AC 43-0610-R2

Subject: AC43 Draft Comments, June 2010

SUBJECT: AC43-0610-R2

Proposed Revisions to the Acceptance Criteria for Steel Deck Roof and Floor Systems

**AISI Lap Joint Shear Tests
Steel Deck Fastened to 3/8 Inch Base Steel
with Hilti X-ENP-19 Power Actuated Fasteners (2)**

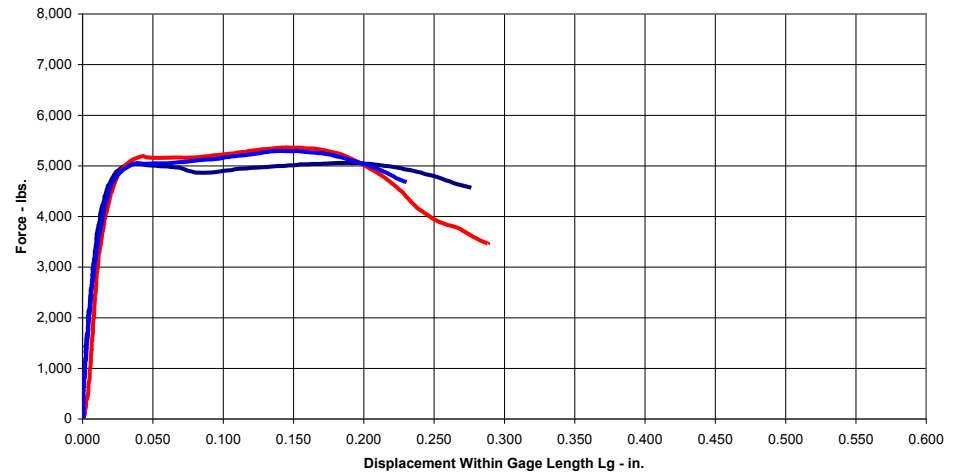
Small scale connection performance provides only a basis for understanding of the diaphragm system behavior. What it misses: edge effects of steel deck panels, endlaps influence, diaphragm system effects among others... Under this AC43 draft, essentially to qualify a fastener for diaphragm use, less tests are required than even for an AC118 screw fastener qualification, despite the fact that the connections are a critical part of a larger structural system that's recognized for seismic resistance!

Diaphragm Decking Test
May 15, 2007

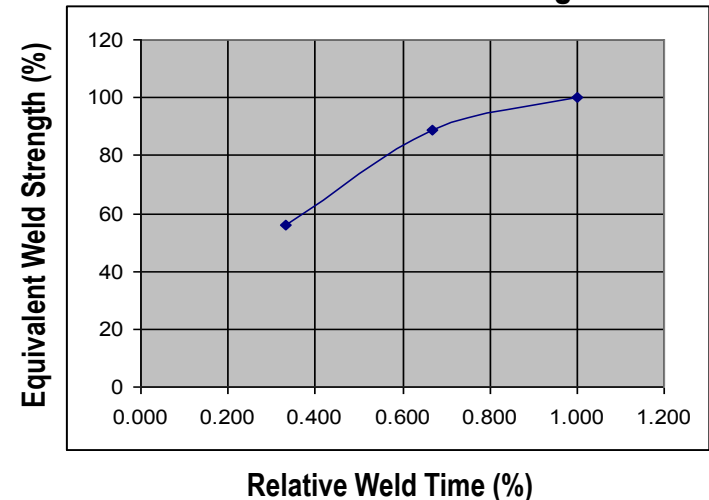
Cyclic / seismic testing is not currently part of AC43, but similar to AC230 and AC269 racking shear wall tests, this should be included to verify the ductility of the diaphragm system. Similar to AC118, AC120, AC193 and AC308, various product performance levels should be allowed / recognized.

Steel Deck – Frame Fasteners after Cyclic Loading

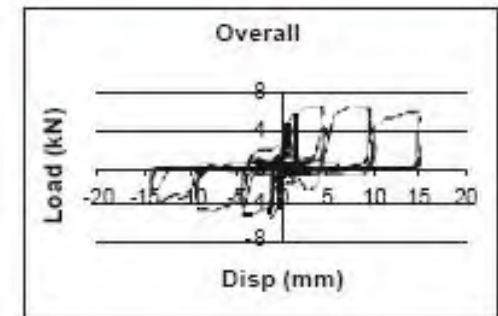
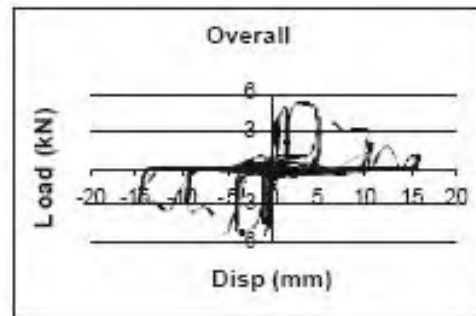
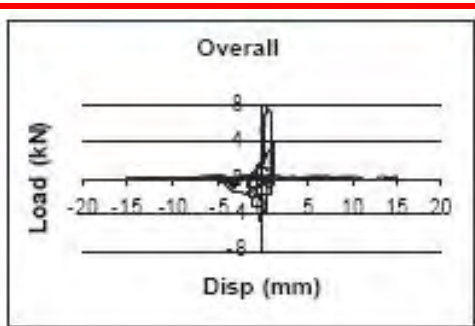
“Welded deck-to-frame fasteners provide diaphragms with limited ductility capability. Substantial degradation of strength occurs when the diaphragm is subjected to cyclic loading within the inelastic range”

Tri-Services Manual 1992

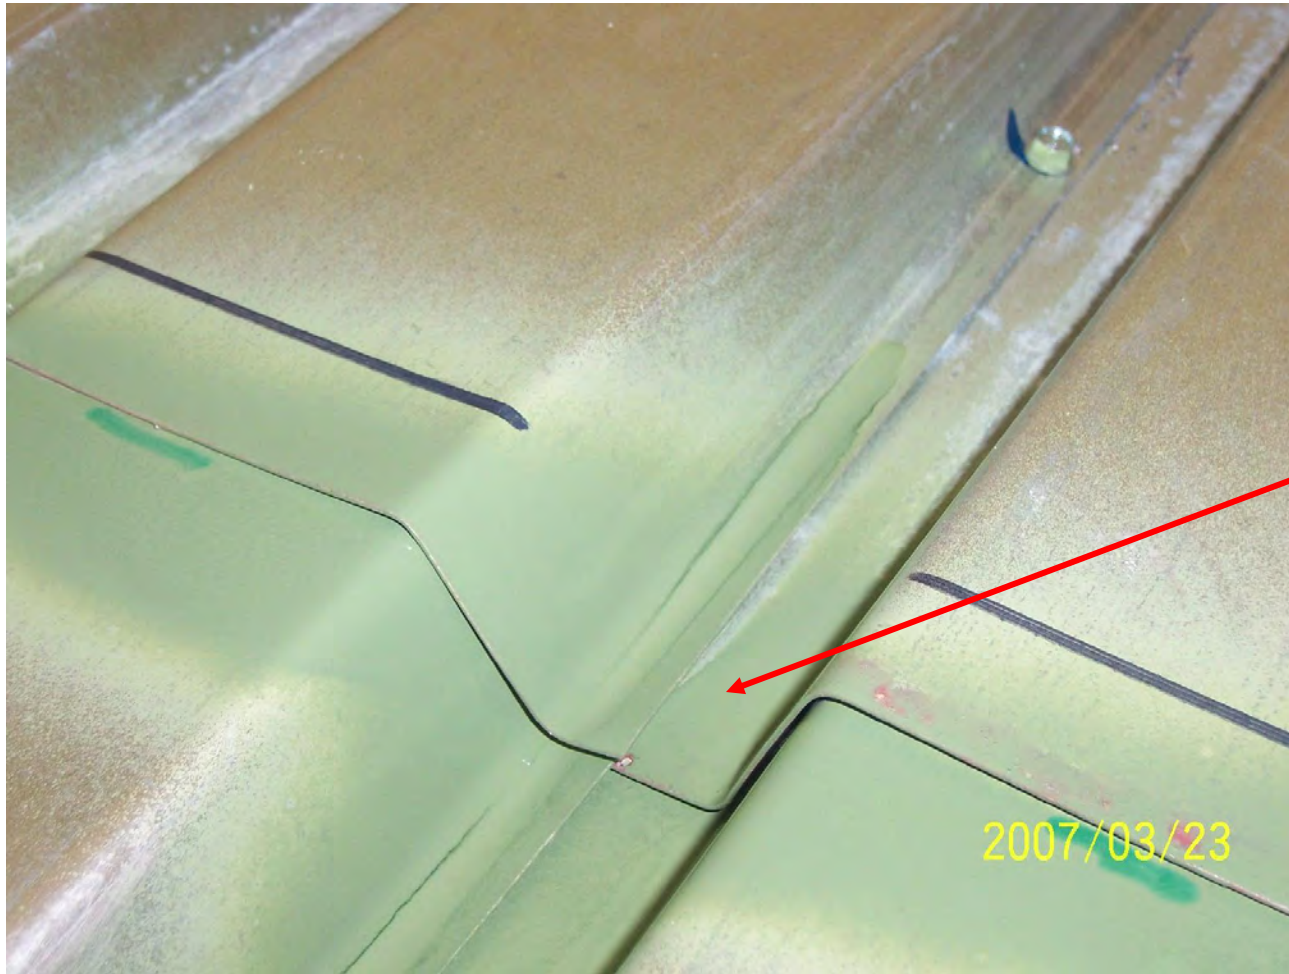
Allowance was made in the Tri-Services Manual 1992 for use of other fastening methods besides welding:

(5) Nonwelded fasteners. Fastening methods other than welds—such as self-drilling, powder actuated, or pneumatically driven fasteners—may be used provided that equivalence to the welded method can be shown by approved test data. The results of such test data will be presented by means of equations or tables for q and F in a manner similar to that used in paragraphs 5-9b, 5-9c, and 5-9d.

Tightly Nested Endlaps

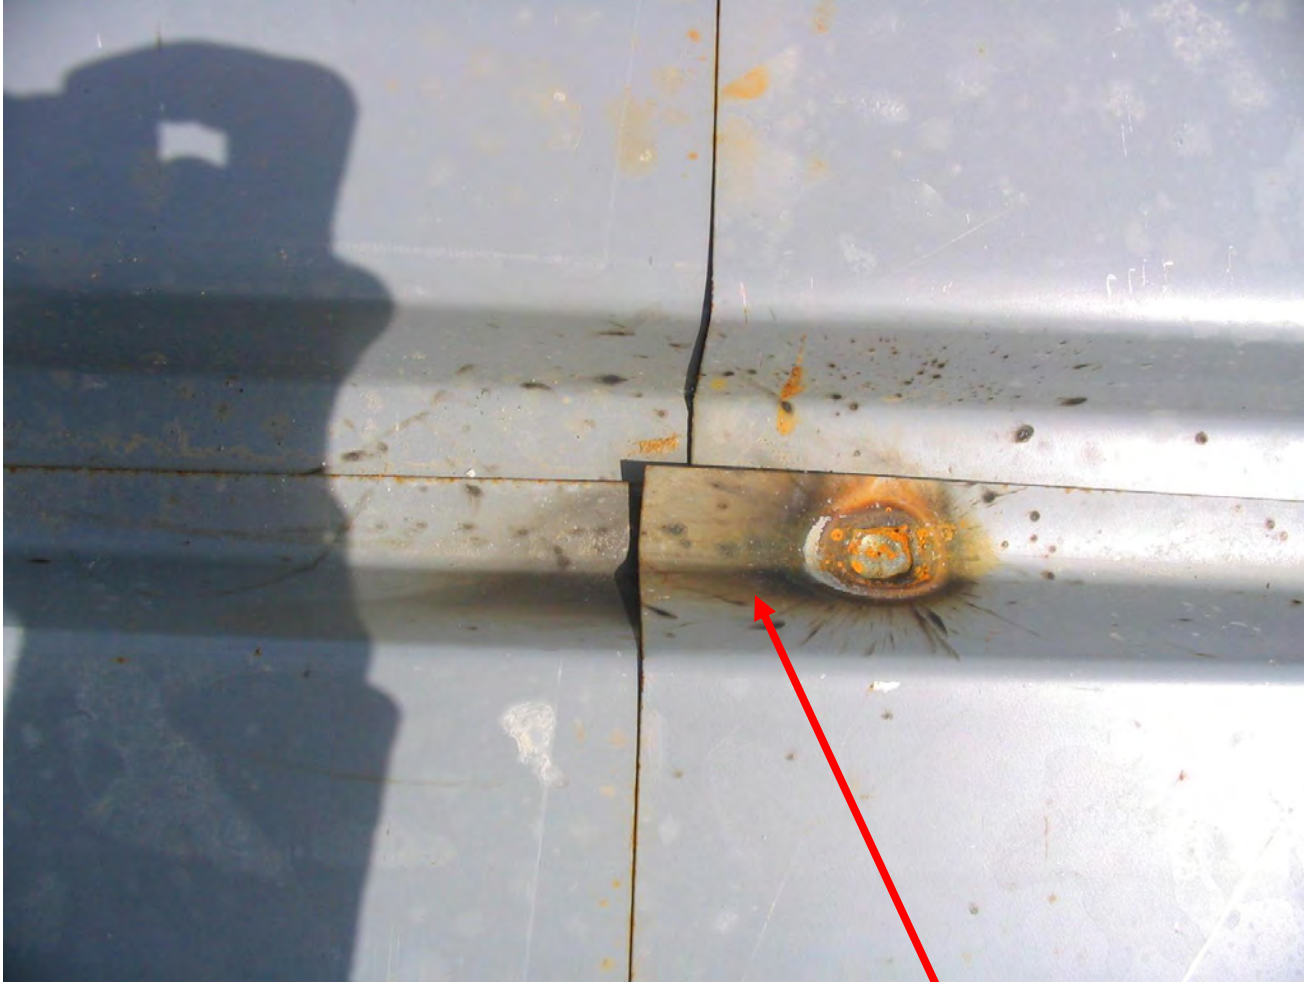
Loose endlap / corner connection
Weld capacity could be questionable (ref. Easterling research)

Short Sidelap Edge on Steel Deck Panel

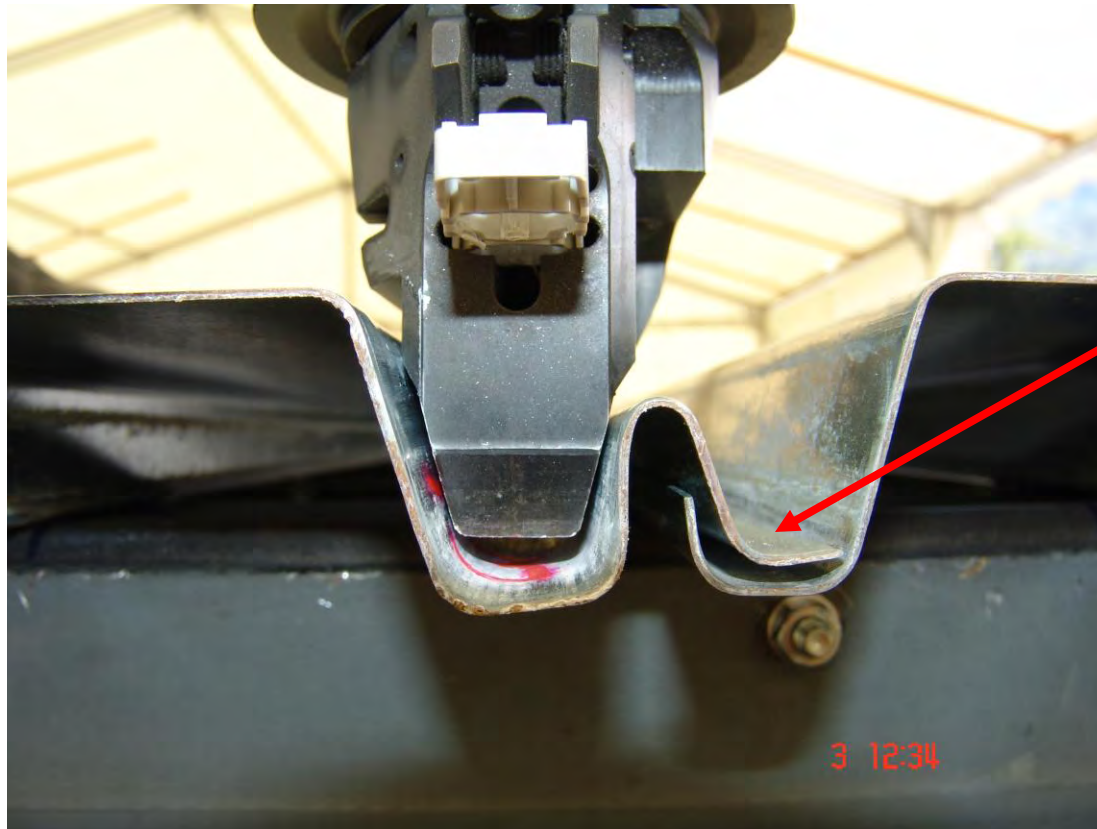
Nestable steel deck panels can be manufactured this way. The sidelap edge may not extend for a full lap across the lower flute.

Nestable steel deck panel may have a complete / full sidelap edge where it nests on top of the adjacent steel deck panel. It may also have a “short” sidelap edge. This condition is only captured in the full-scale diaphragm system test (AISI S907).
